# Statement of Environmental Effects

Modification of approval (DA/55/2021 – Modification 2)

5-9 Croydon Street, Lakemba

Figure 3: Approved deep soil extent

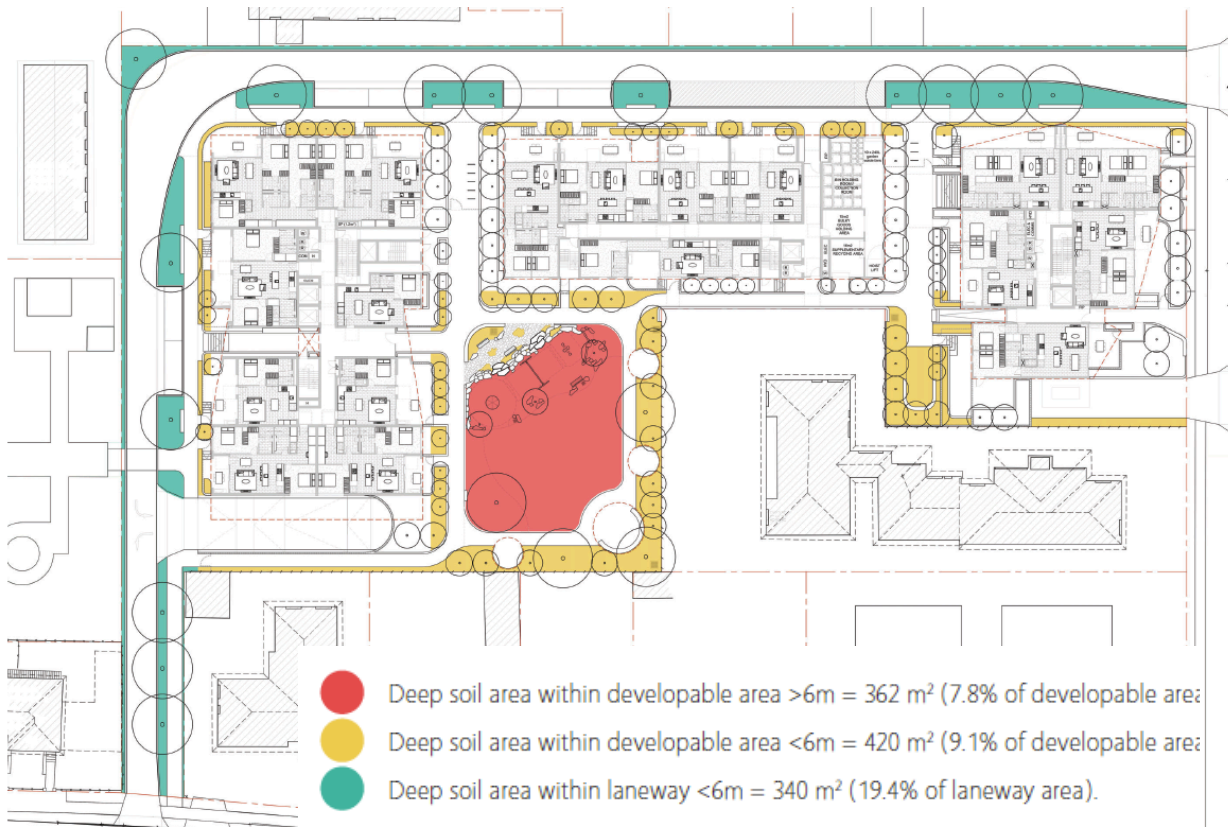
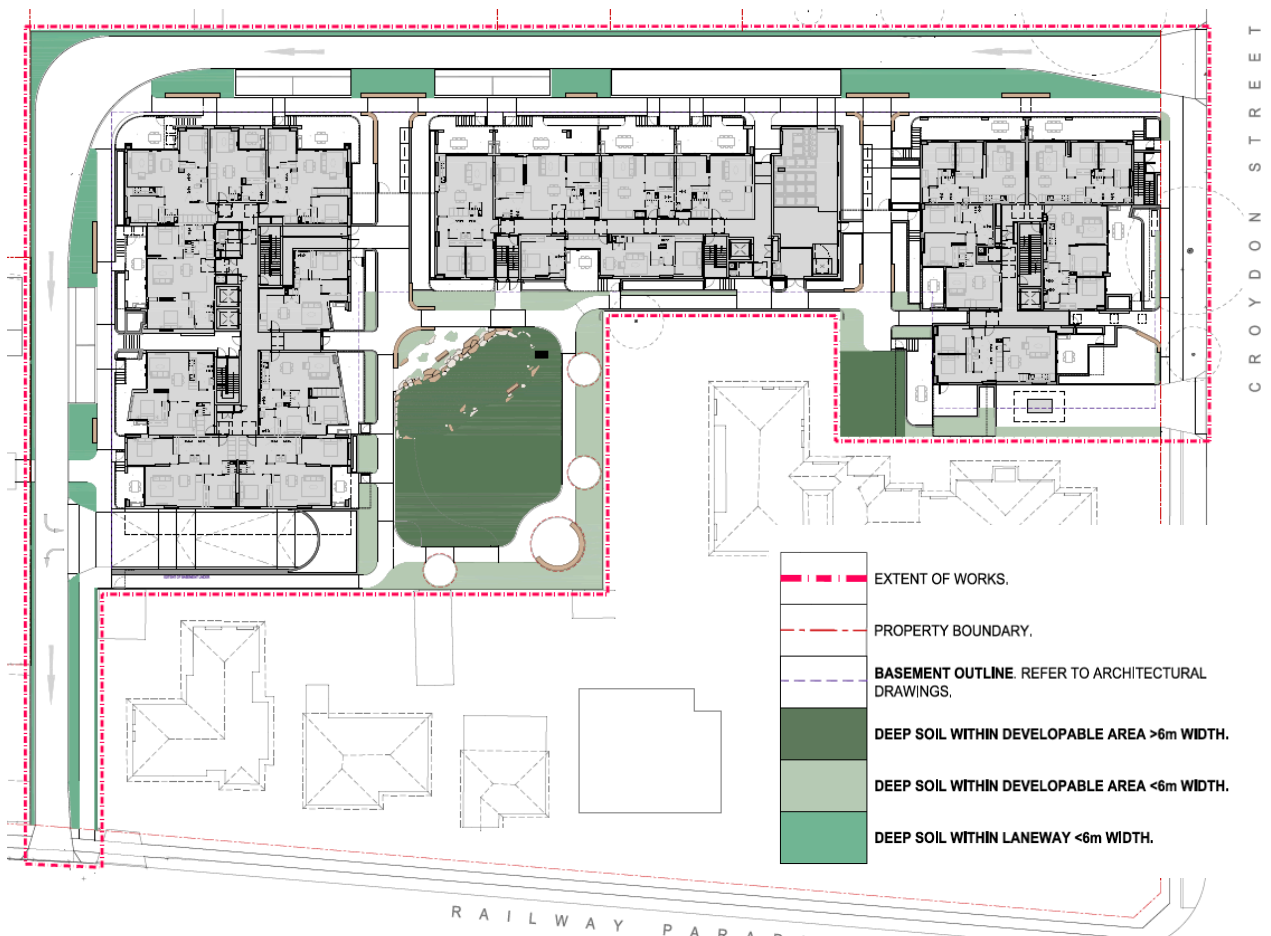
The proposed minor increase to the extent of basement excavation to accommodate the exhaust plenum has resulted in a minor reduction of deep soil located between the laneway and proposed buildings. This change maintains compliance with the requirements of the ADG and site-specific DCP. The areas previously identified as deep soil will maintain a consistent landscape design with planting to be in planters over the basement rather than deep soil.

Overall the decrease is minor representing only a 2.4% reduction in deep soil across the developable area with the areas to be removed limited to narrow strips of deep soil and the overall landscape and canopy cover outcome still able to be achieved.

Approved deep soil	Proposed deep soil
Deep soil within development area > 6m dimension	362sqm / 7.8% of developable area	408sqm / 8.8% of developable area
Deep soil within development area < 6m dimension	420sqm / 9.1% of developable area	259sqm / 5.6% of developable area
Total deep soil within developable area	782sqm / 16.9% of developable area	667sqm / 14.5% of developable area
Deep soil within laneway <6m width	340sqm / 19.4% of laneway	343sqm / 19.6% of laneway
